# Determination 2025/023

## Regarding the issue of three code compliance certificates and compliance of items of building work

### 3 Sideys Road, RD 24, Southburn, South Canterbury

**Figure 1: South view of kitchen and dining room extensions, and east view of bedroom extension**

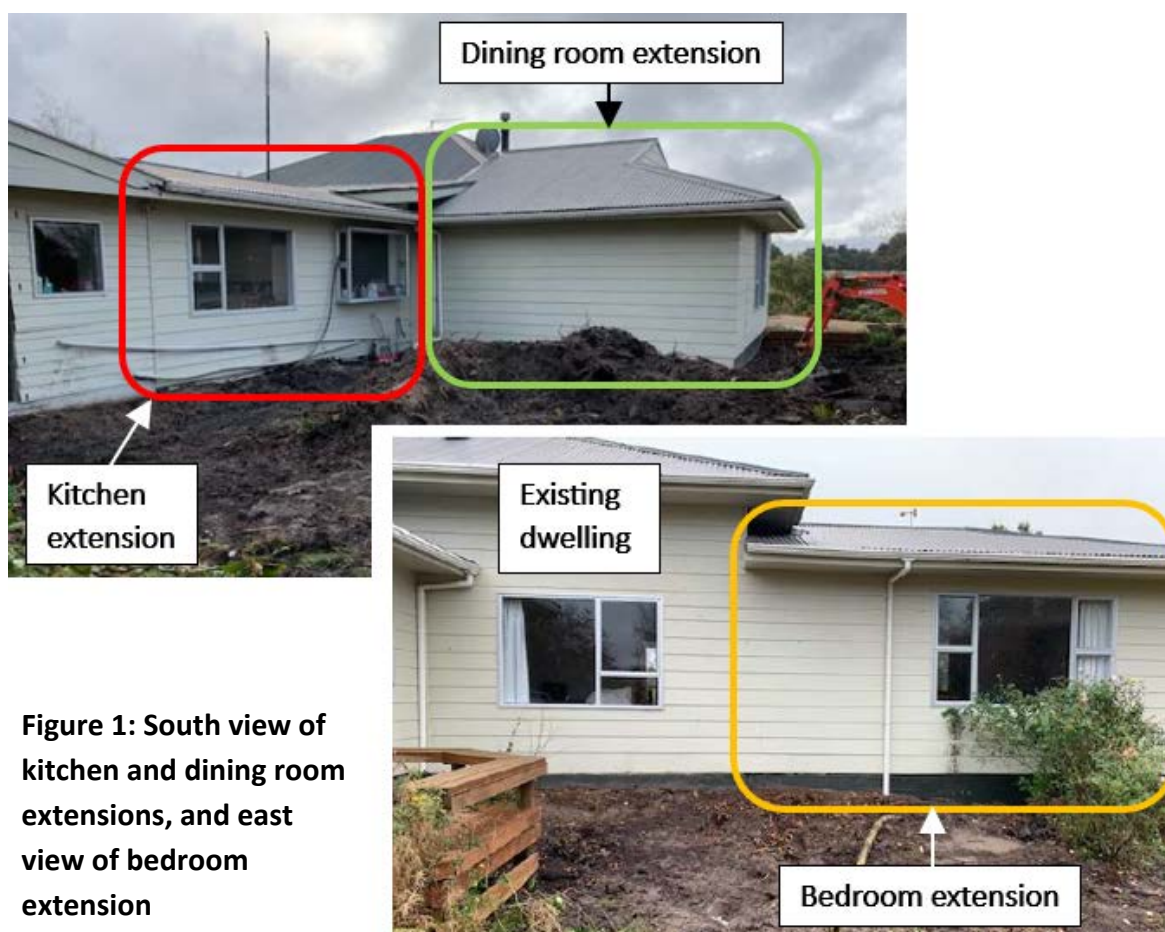
- 2.5. The building work was an approximate 40m<sup>2</sup> extension to the east side of the existing dwelling. The construction consisted of timber piles, subfloor, wall framing and prefabricated roof trusses. The wall cladding was horizontal fibre-cement weatherboards incorporating aluminium joinery, and the roof cladding was lightweight profile metal.

- 2.8. The building work was an approximate 22m<sup>2</sup> extension between an existing garage and the existing dwelling.<sup>9</sup> Approximately 7m<sup>2</sup> of the floor was an "existing wooden floor" adjacent to the main dwelling. The remaining floor area was a new 50mm thick concrete topping floor laid on a damp proof membrane above 100mm thick 'existing concrete'. The construction consisted of timber wall framing, prefabricated roof trusses at 1.8m centres and purlins. The wall cladding was fibre-cement weatherboards incorporating aluminium joinery, and the roof cladding was lightweight profiled metal with a roof underlay.
